December 10, 2019

**Addendum No. 01
TO THE CONTRACT DOCUMENTS FOR:**

MANSFIELD FIRE STATION NO. 4

KAI Project No. 2016.166

05 HIGH/LOW ROOF @ 12" CMU 3/4" = 1'-0"

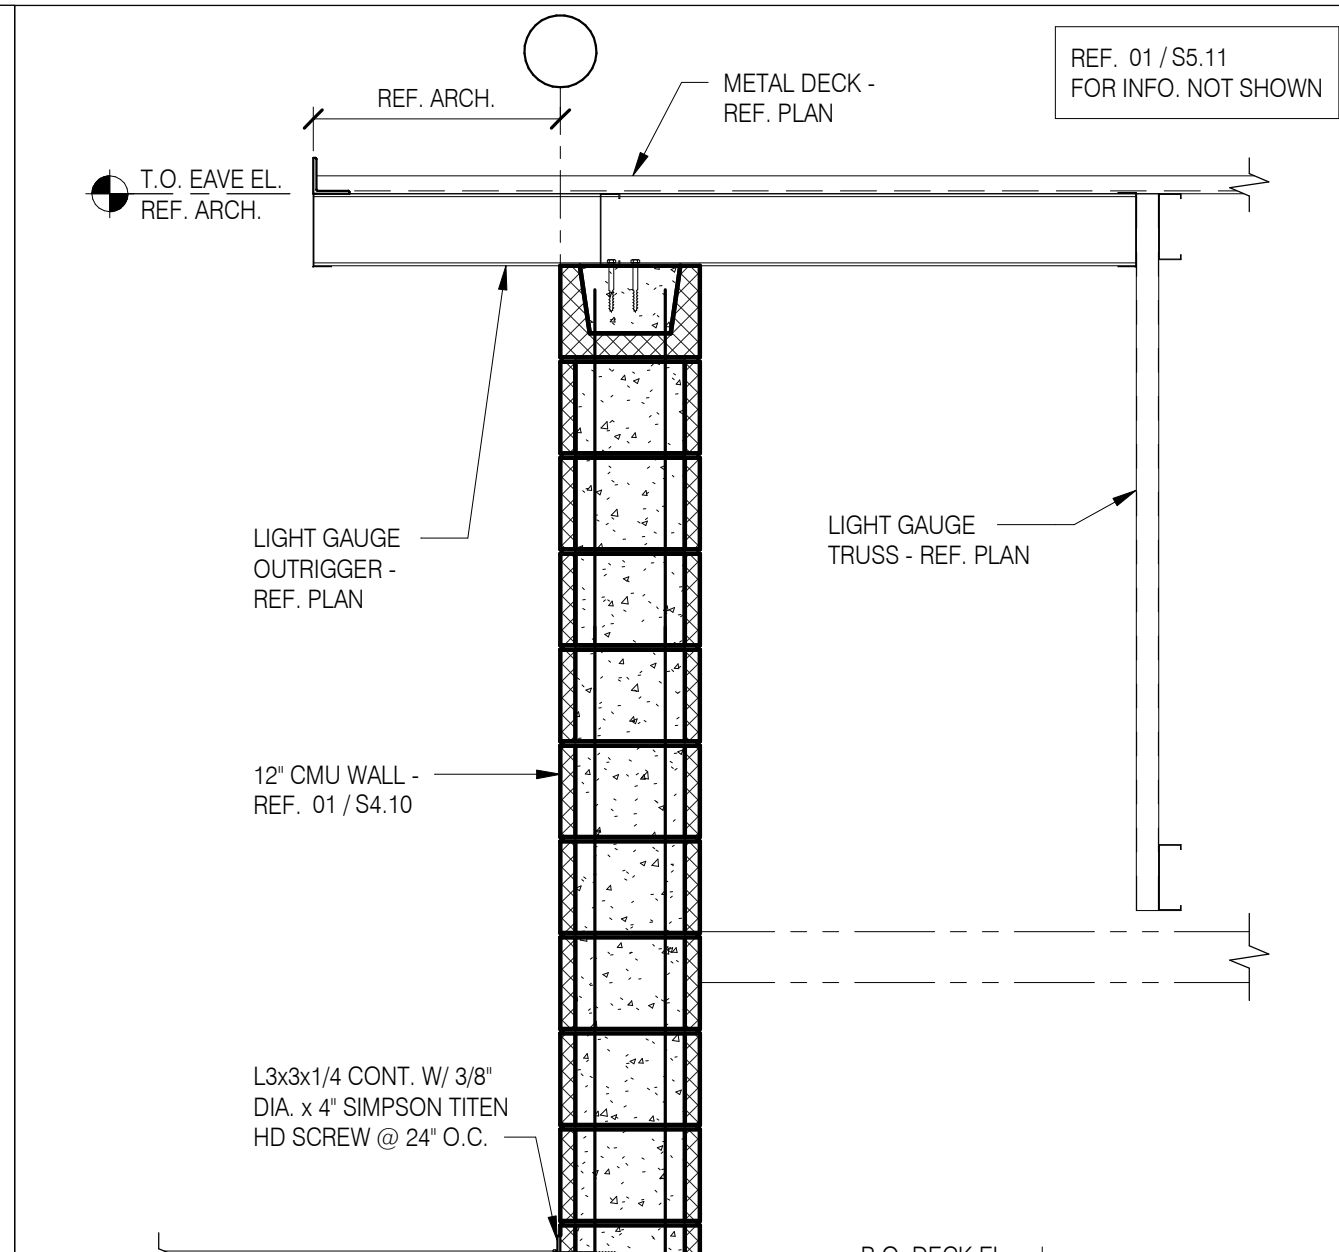
21. Sheet S5.11 – Detail 6 – Revised Top of steel for workout structure.
22. Sheet S5.13 – Detail 5 – Revised T.O.S. elevation.
23. Sheet M0.02 – Revised FAN SCHEDULE

SHEET SIZE:	22 x 34
JOB NO:	2016.166
DATE:	11/19/2019
SHEET:	M2.01

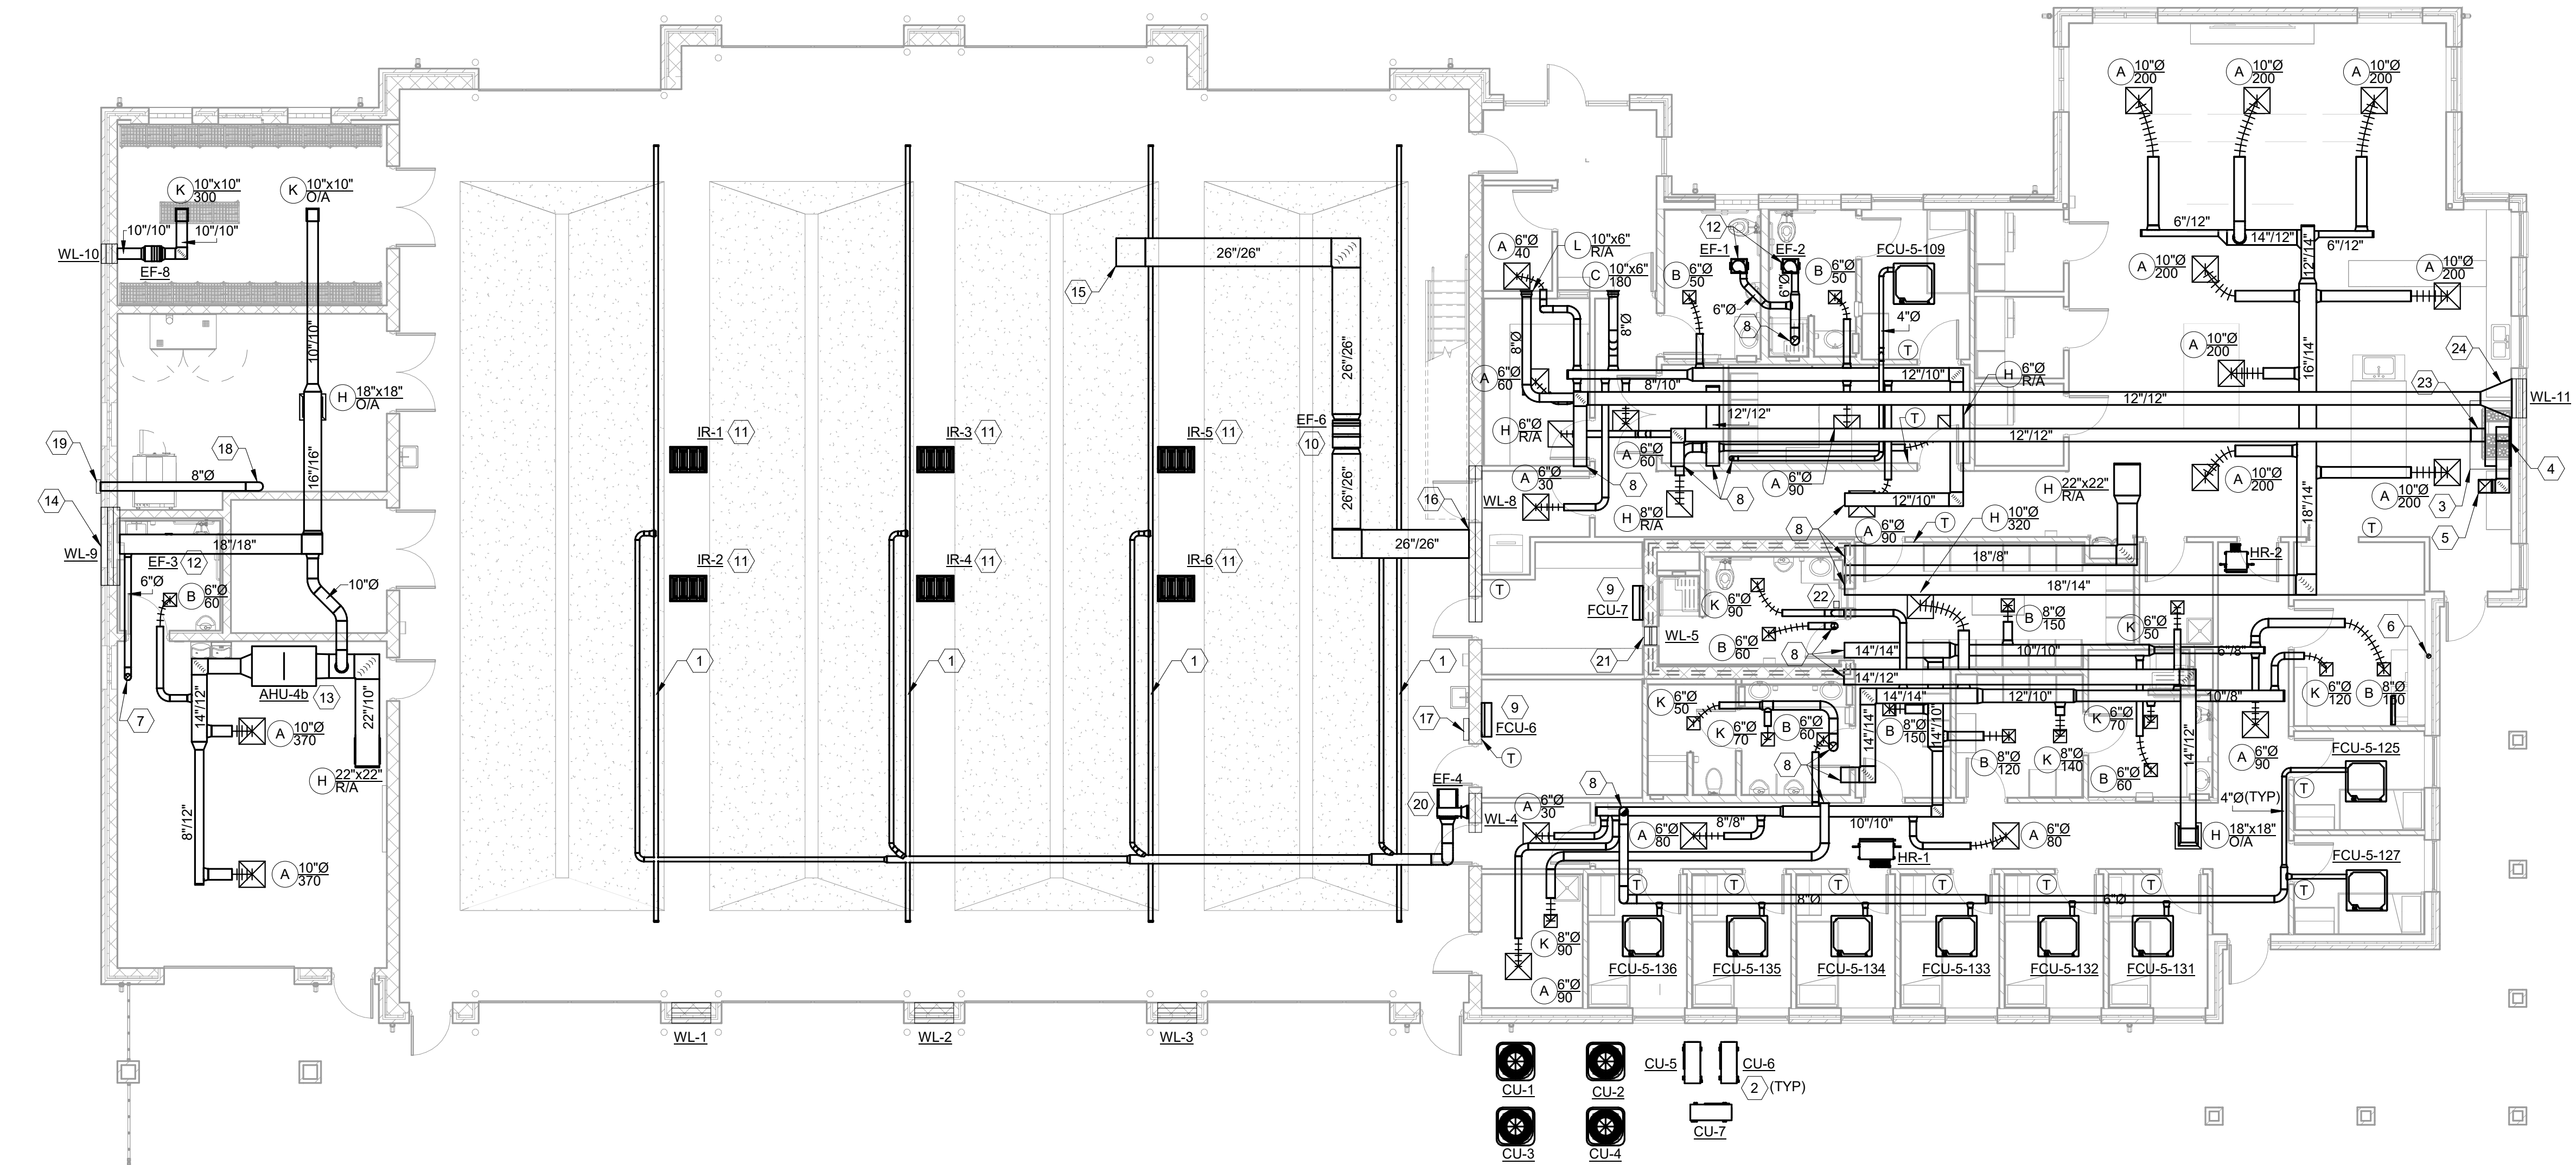
24. Sheet M0.03 – Revised LOUVER SCHEDULE and added INDIRECT-FIRED MAKE-UP AIR UNIT WITH GAS HEAT SCHEDULE.
25. Sheet M2.01 – Added duct work for GEAR 143. Revised duct alignment above Corridor 103 and 107.

4 NATURAL GAS METER DETAIL AND GAS RISER DETAIL
NO SCALE

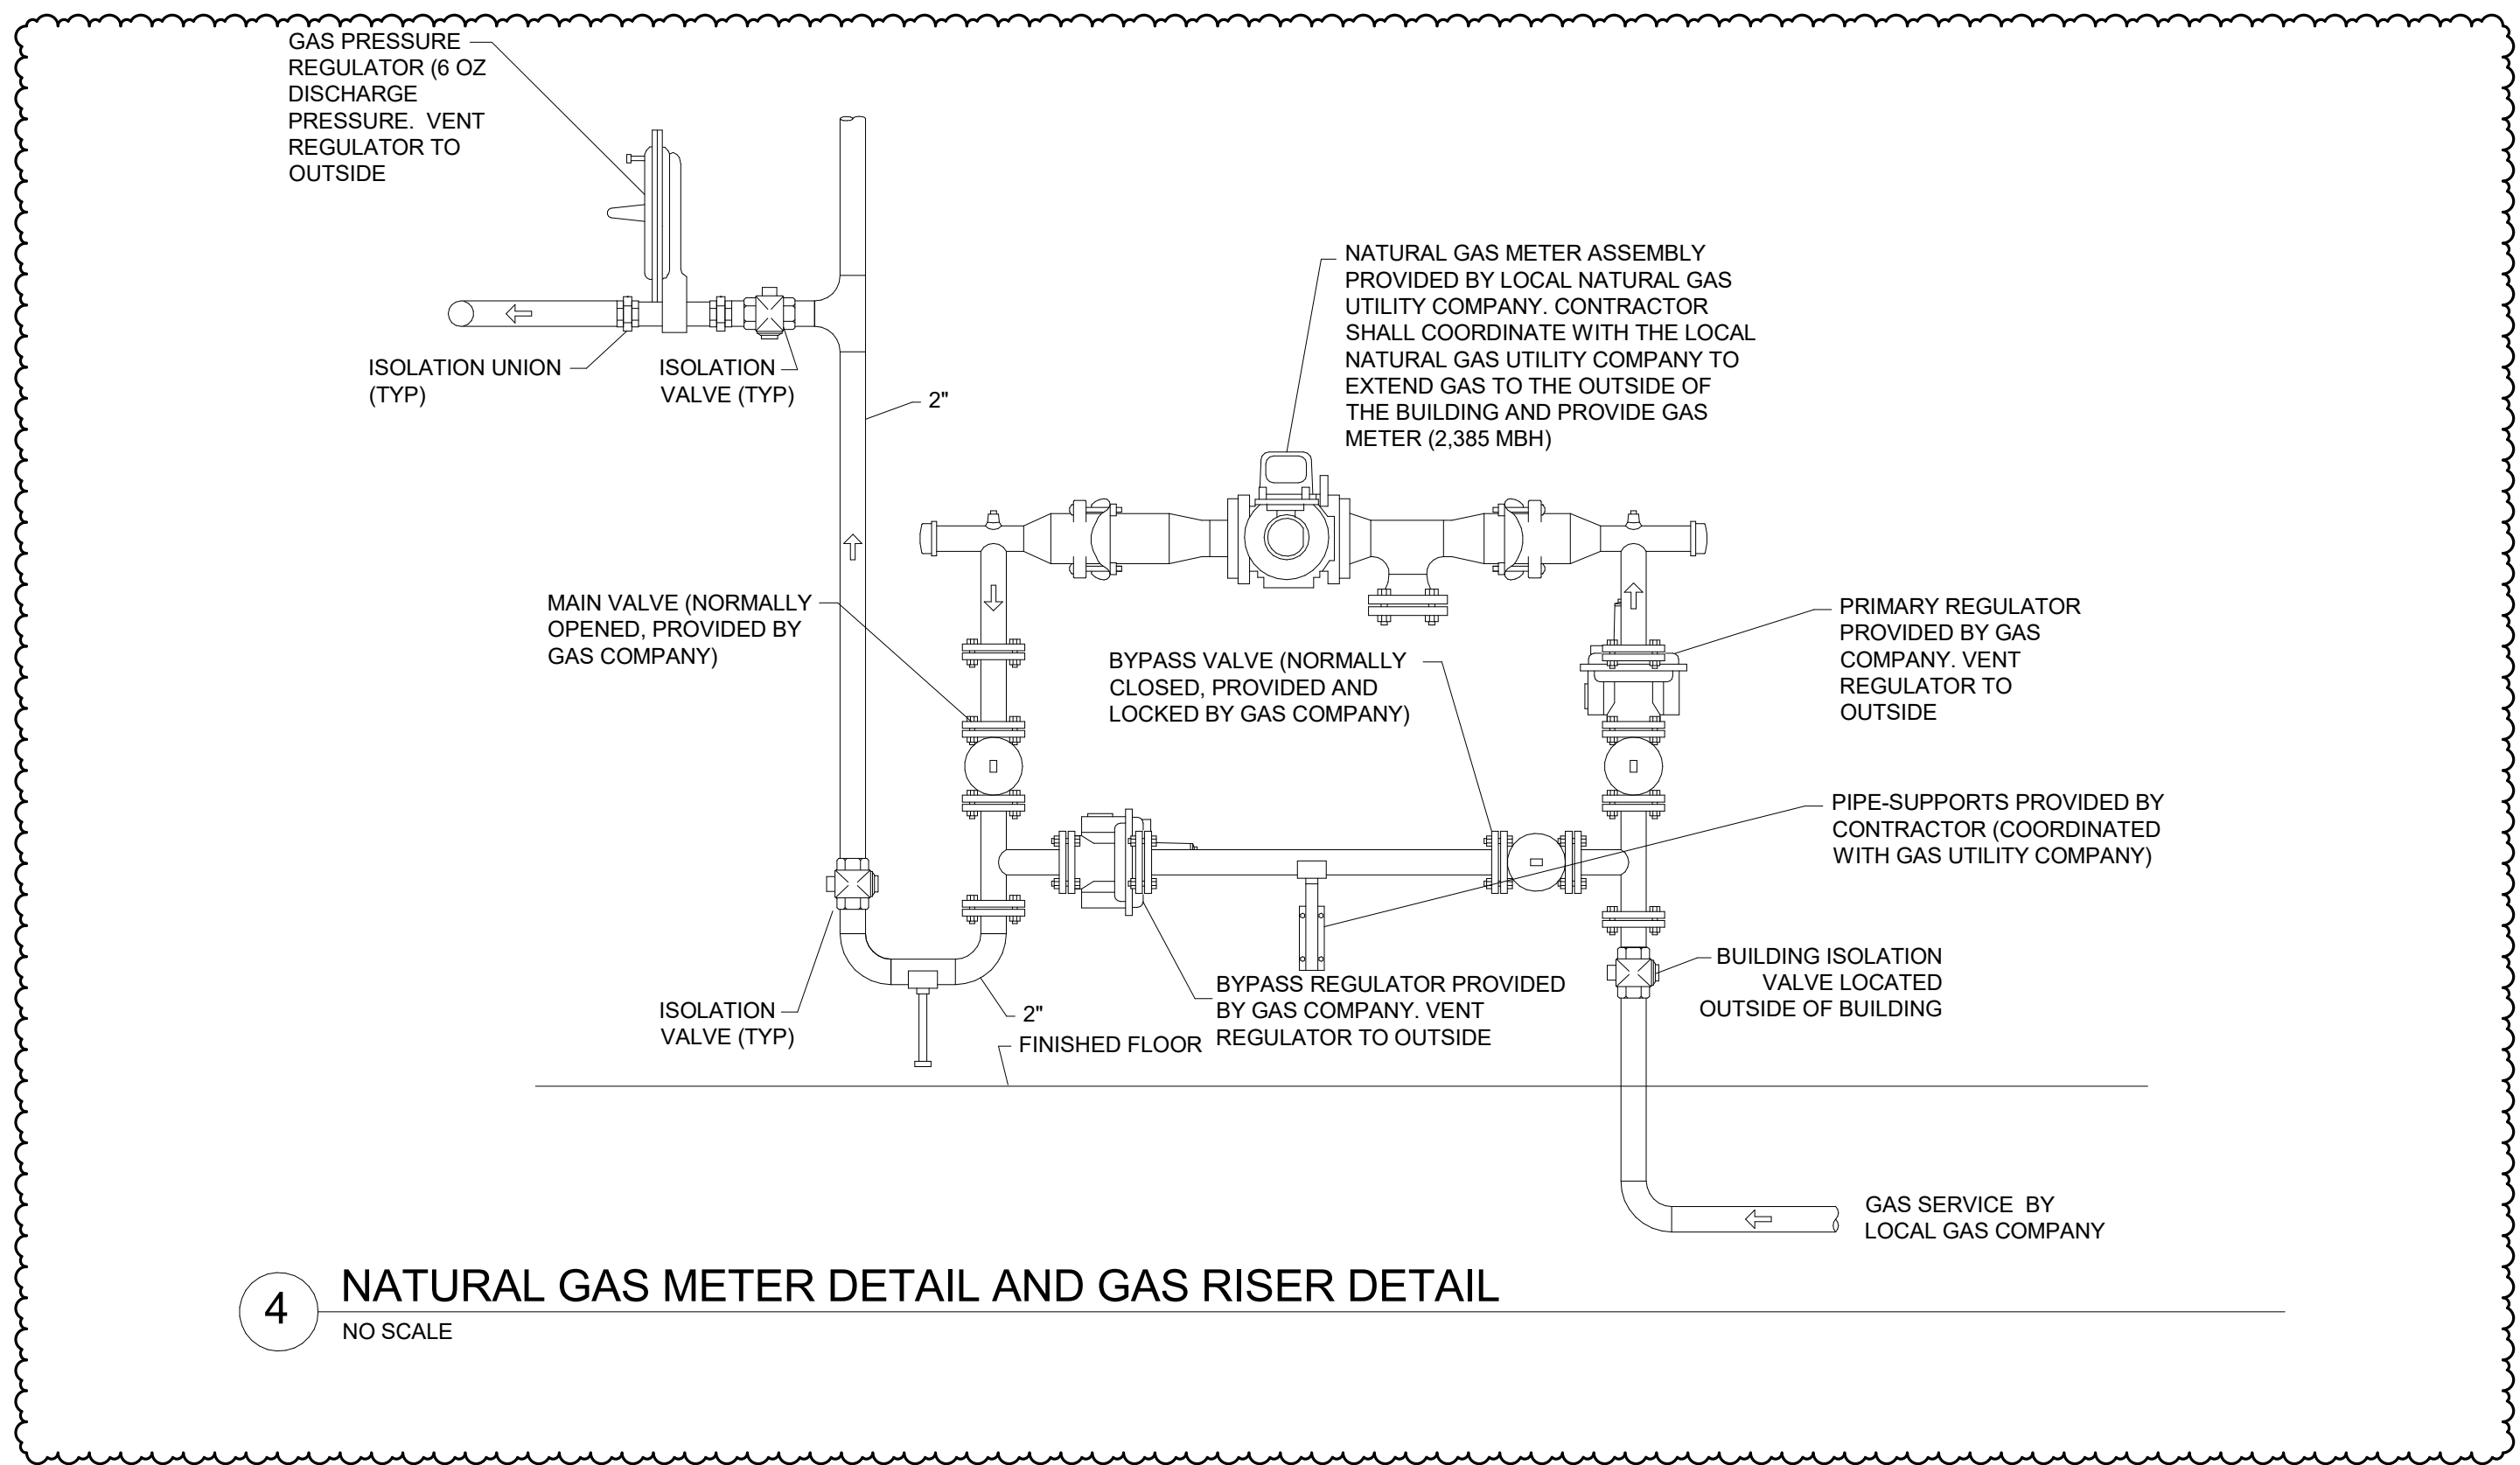
29. Sheet P2.01 – Revised gas line in building and meter location.
30. Sheet P2.02 – Added gas line for MAU-1.
31. Sheet P4.03 – Added Natural Gas Meter detail

1 MEZZANINE PLAN - ELECTRICAL
E2.03 1/8" = 1'-0"

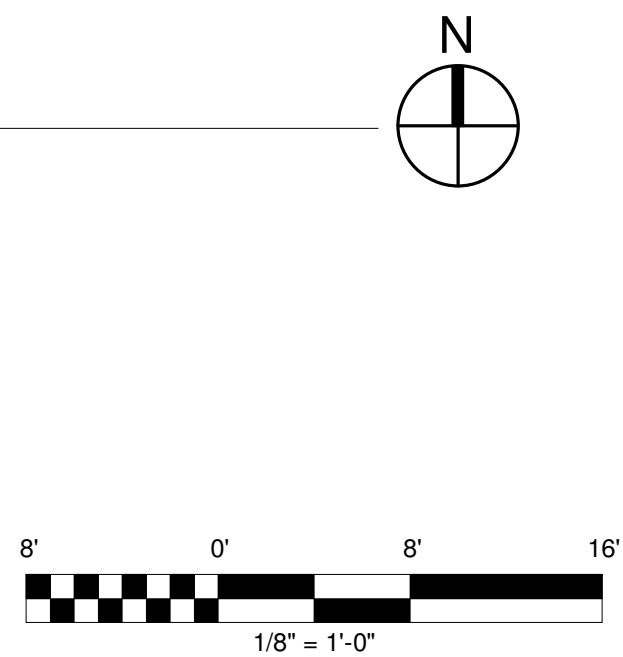
34. Sheet E2.03 – Added power to MAU-1.
35. Sheet E3.02 – Revised lighting control schedule to be more legible.
36. Sheet E6.01 – EQUIPMENT SCHEDULE BY SYMBOL – Added MAU-1.
